TOLEDO-LUCAS COUNTY PLAN COMMISSIONS

DATE: May 10, 2019 REF: SUP-3004-19

Amendment to Special Use Permit, originally granted by Ord. 60-06 and 553-09, for

Location - 3301 Upton Avenue

ALTERNATE 1 PROPOSED SITE PLAN

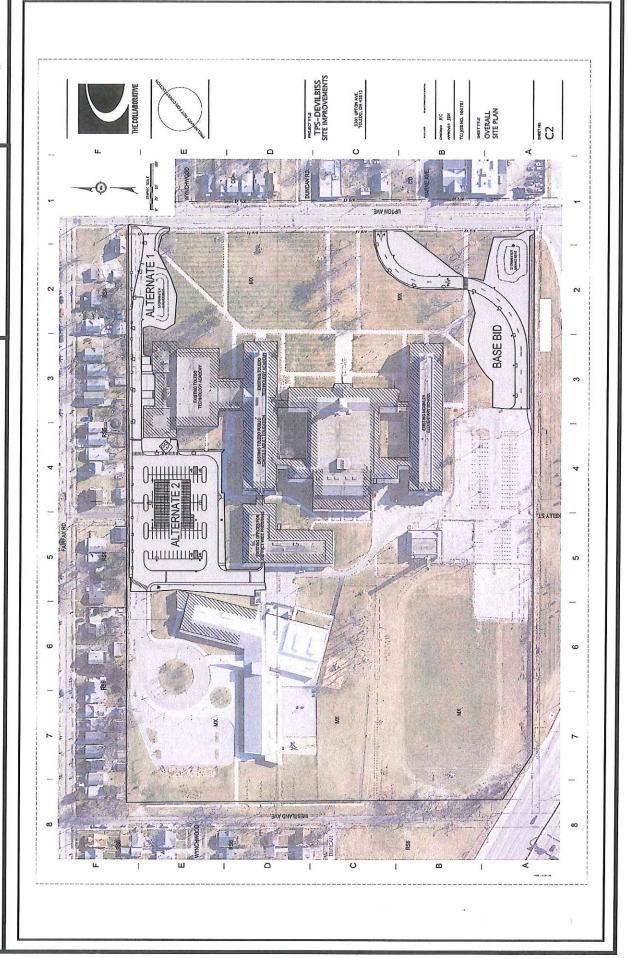
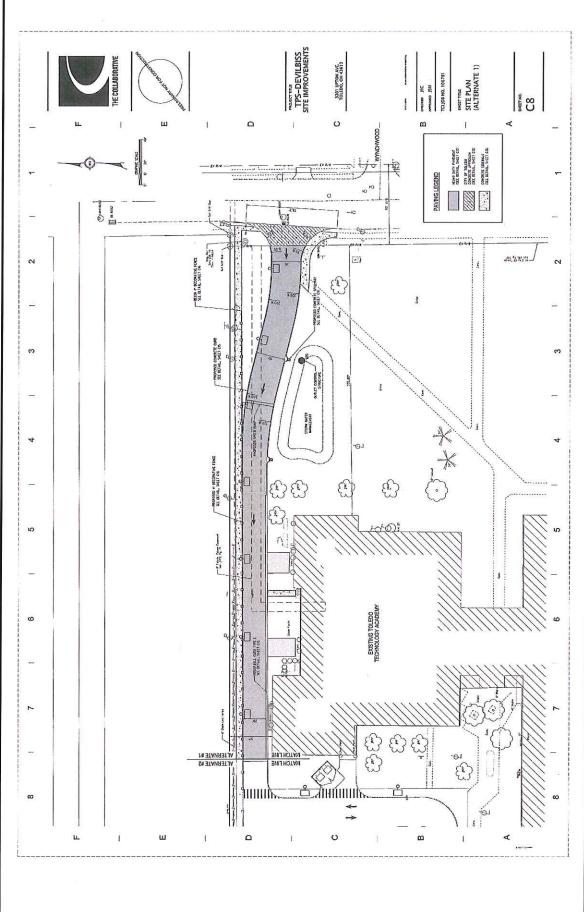
The proposed improvements on the site regarding "alternative #1" will consist of realigning the existing entrance drive, pulling the drive approach slightly south to give more separation between the entrance drive and the pedestrian traffic entering the site. A raised sidewalk will be added along with a four (4') foot decorative fence separating the walk from the drive. These improvements are intended to improve safety as well as improve the aesthetics of the entrance.

ALTERNATE 2 PROPOSED SITE PLAN

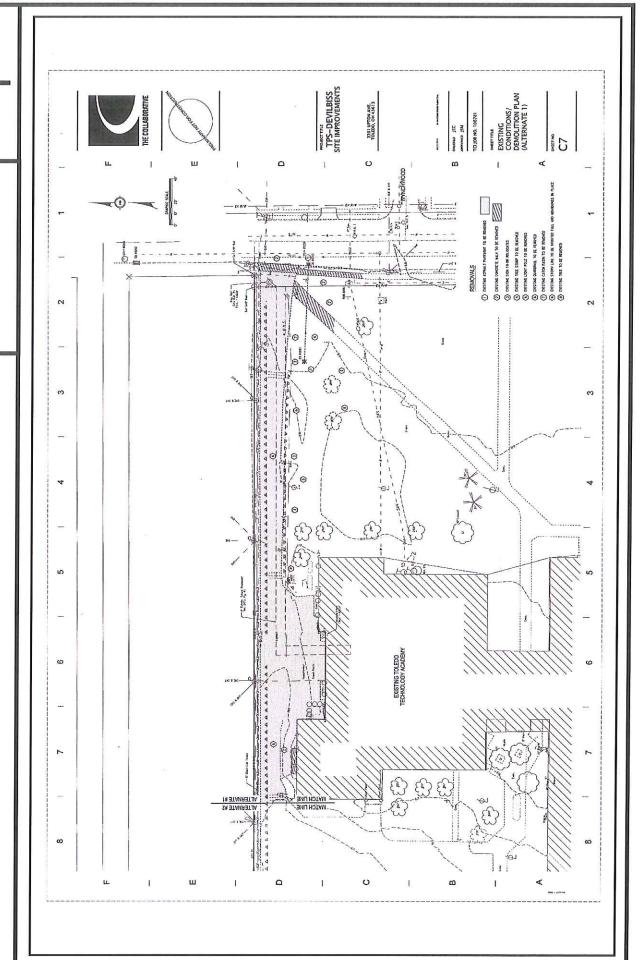
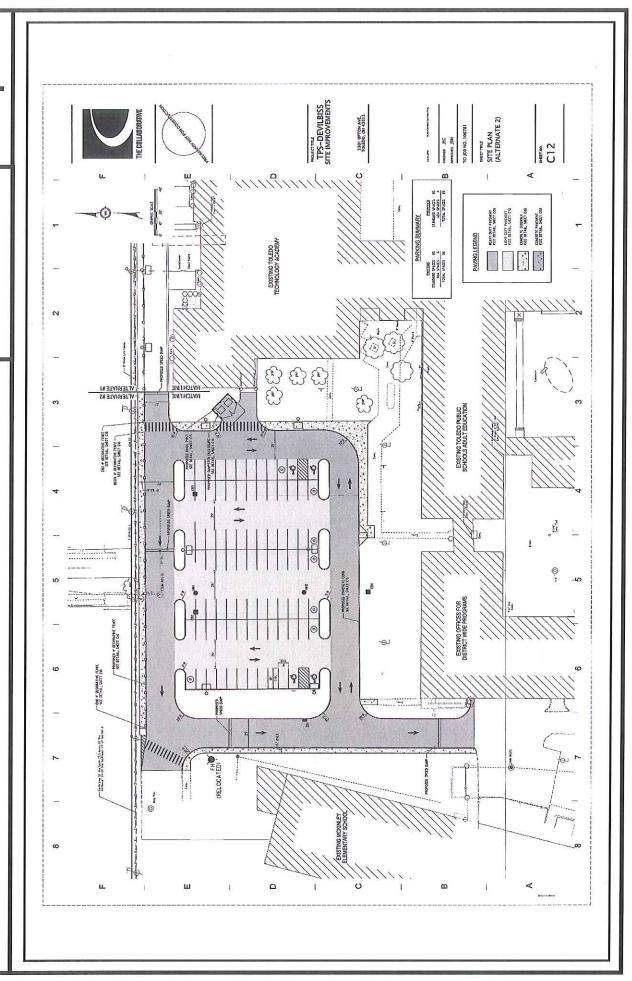
The proposed improvements on the site regarding "alternative #2" will consist of extending the raised walkway and decorative fence the rest of the way down to McKinley Elementary. Other improvements involve the repaving and restriping the existing parking lot. Landscaping islands will be added in order to improve traffic circulation and by providing an oversized landscape island that will provide additional green space and improve the aesthetics of the parking lot.

The parking area that is to be improved currently offers sixty-two (62) parking spaces. Following the proposed improvements the parking area will offer eighty-nine (89), a net gain of twenty-seven (27) spaces. Pursuant to TMC§1107.0302 *Parking, Loading, and Access*, no use may provide more than 150 percent of any of the minimum off-street parking ratios of parking Schedule A. The submitted site plan is in compliance.

A portion of the total number of required off-street parking spaces in each off-street parking area must be specifically designated, located, and reserved for use by persons with physical disabilities. According to TMC§1107.1701 – *Number of Required Parking Spaces for Persons with Disabilities*, the applicant is required to provide at least three (3) accessible parking space for persons with physical disabilities. The site plan submitted depicts four (4) accessible parking spaces close to the entrance and is in compliance with this regulation.

Bicycle parking slots shall be provided pursuant to Off-Street Parking Schedule "A" (TMC§1107.0300). Off-Street Parking Schedule "A" requires one (1) bicycle parking slot per ten (10) parking spaces. Calculations conclude that a total of nine (9) bicycle parking slots are required. The site plan submitted does not depict compliance with this regulation. Listed as a condition, a revised site plan will be required to show compliance with the appropriate number of bicycle parking spaces.

BASE BID PROPOSED SITE PLAN

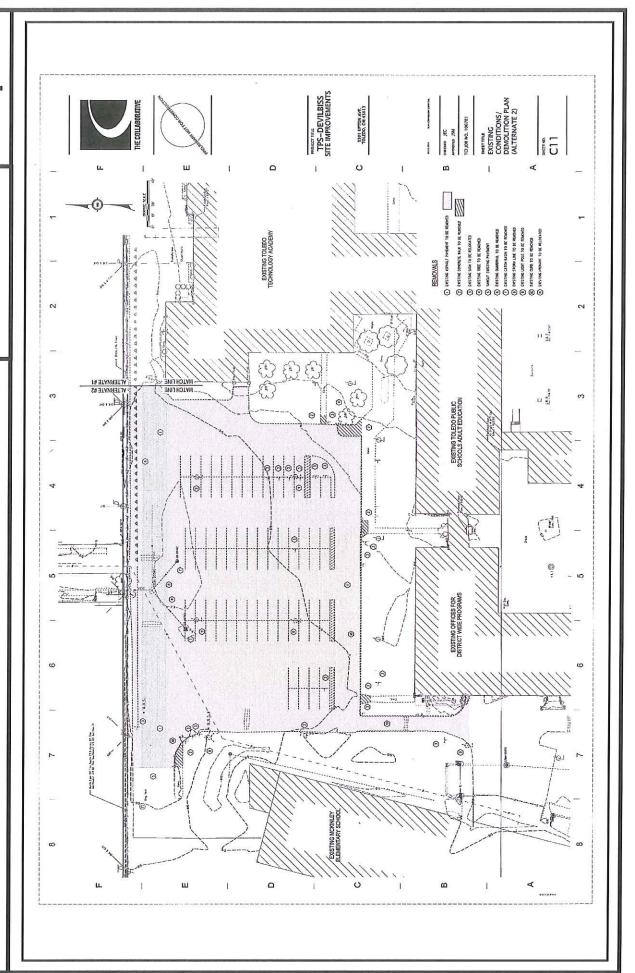
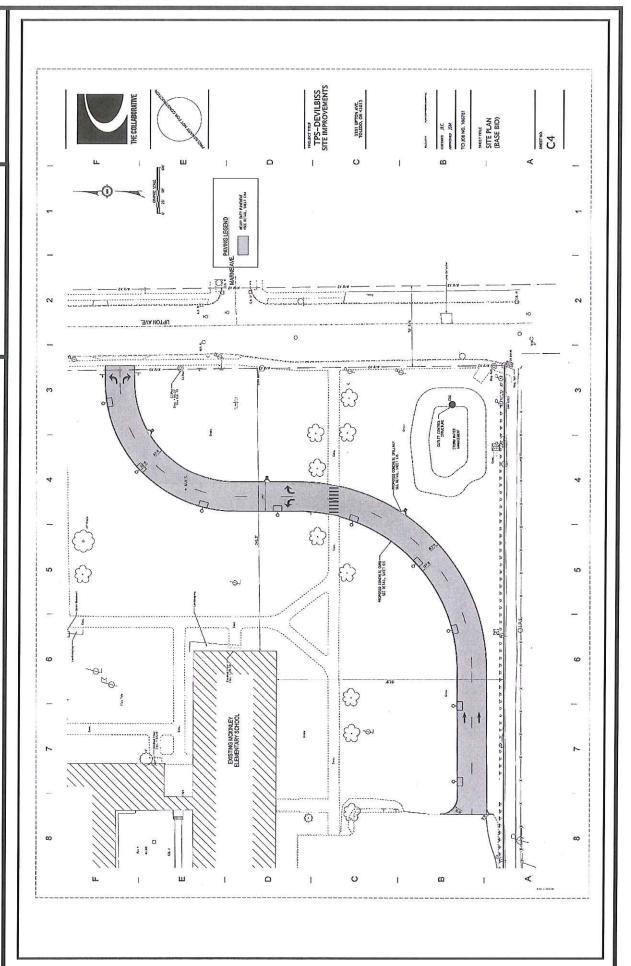
The proposed improvements on site are intended to improve circulation, as well as provide improvements to an existing parking lot in need of repair. The "base bid" for the project will consist of re-aligning the existing southern exit-only drive so that traffic moving through the site will no longer drive through the center of the existing parking lot in order to leave the campus. The drive will be slightly widened as well, in order to provide two lanes the entire length to improve stacking for those waiting to turn onto Upton Avenue.

OVERALL LANDSCAPE PLAN

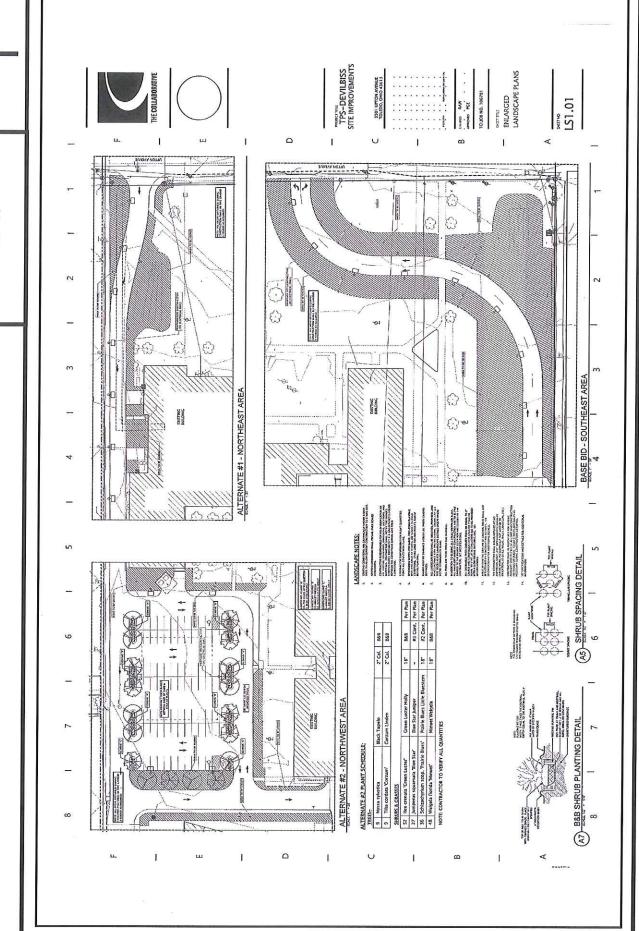
Landscape areas within the parking area must be peninsular or island types and must be constructed with 6 inch by 18 inch concrete curbing, cast-in-place, extruded, or by some other process approved by the Planning Director, to minimize damage to plant material. Landscape terminal islands must be provided at the end of each parking row. Two (2) canopy trees are required to me installed in interior landscape areas for every ten (10) parking spaces within the parking lot. Additionally, six (6) shrubs are required to be installed in interior landscape areas for every ten (10) parking spaces within the parking lot. The landscape plan submitted is in compliance with these requirements.

h. Landscape terminal islands must be provided at the end of each parking row. Two (2) canopy trees are required to me installed in interior landscape areas for every ten (10) parking spaces within the parking lot. Additionally, six (6) shrubs are required to be installed in interior landscape areas for every ten (10) parking spaces within the parking lot. (Acceptable as submitted on landscape plan);
